ALMA CHANGE REQUEST

Date submitted: 2009-08-07
Revised 2009-09-04
CRE #: ALMA-40.00.00.00-200-A-CRE

TITLE: Change the Band 6 Receiver Output IF range in the ALMA Front End Specifications Document

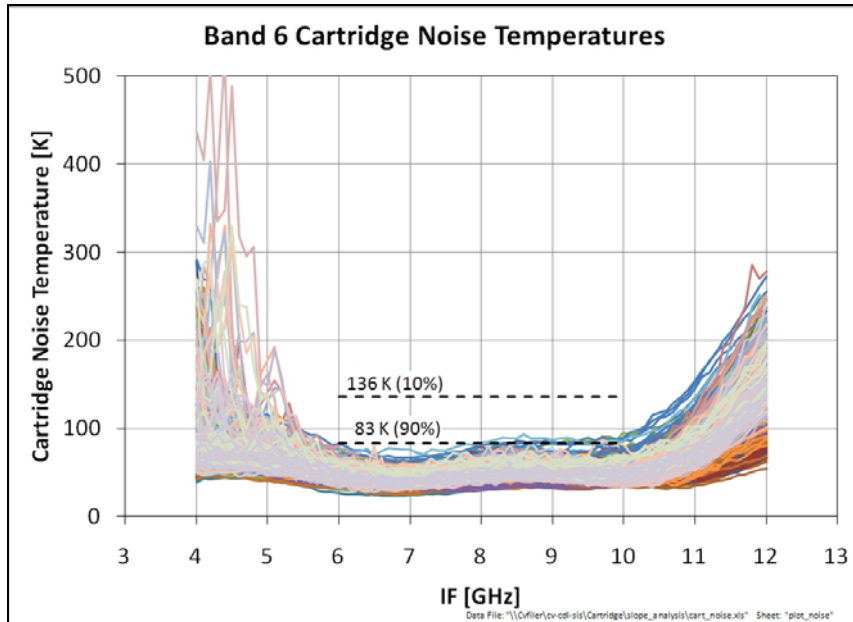
For the CCAs, the average noise over 4.3 – 10 GHz IF range does not meet specification. Even more significantly, the noise performance over 4.3 – 6 GHz is significantly worse than that over 6 – 10 GHz IF range. See [Figure 1](#) and [Figure 2](#).

To: 6 – 10 GHz

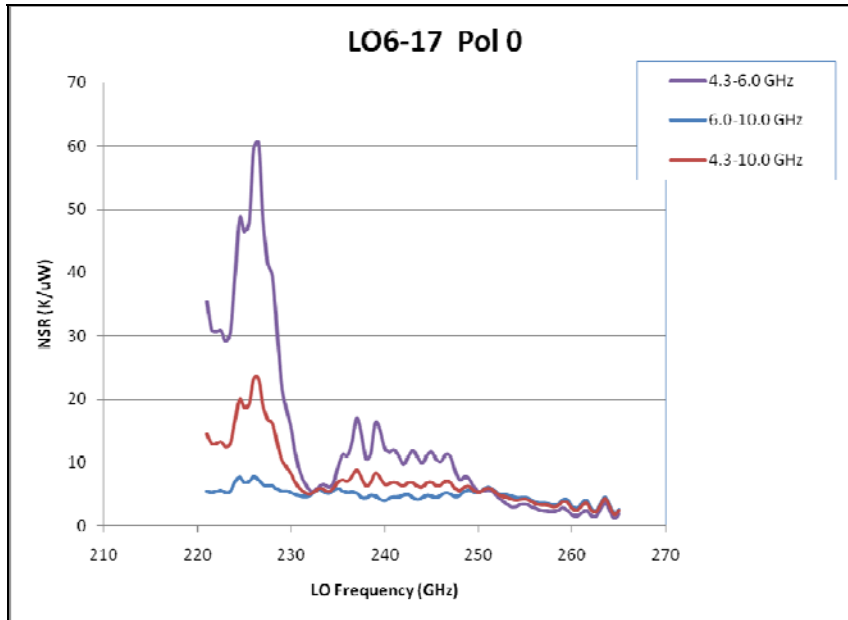
For the WCAs, in some instances the average noise over the full 4.3 – 10 GHz might meet the required specification or only marginally miss it, yet the noise performance over 4.3 – 6 GHz IF range is significantly poorer. See [Figure 3](#) & [Figure 4](#).

Figure 5: Predicted cartridge gain for the best and worst mixer-preamps measured to date.

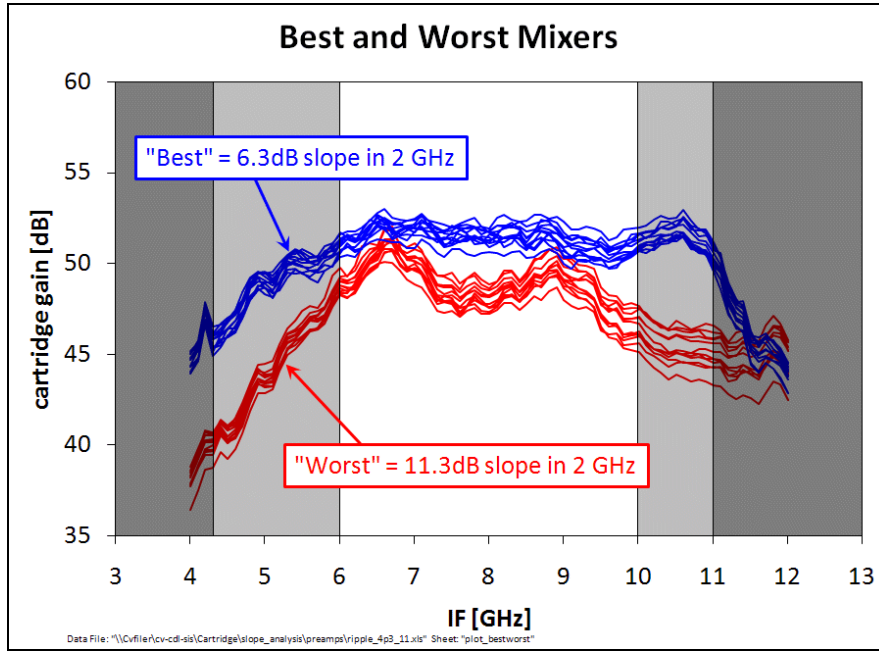
2. Spectral gain/power¹ slope: The CCA is estimated to have a 6 dB gain slope over the 4 – 6 GHz IF range, if the best mixer pre-amps measured to date were to be used [[RD1](#)]. See [Figure 5](#). Actual cartridges have been measured to have a gain slope of about 10 dB over the 4 – 6 GHz IF range. Most of the sensitivity loss due to this poor slope could be corrected by incorporating external equalizers, for instance located in the BE IF processor. See [[RD2](#)].
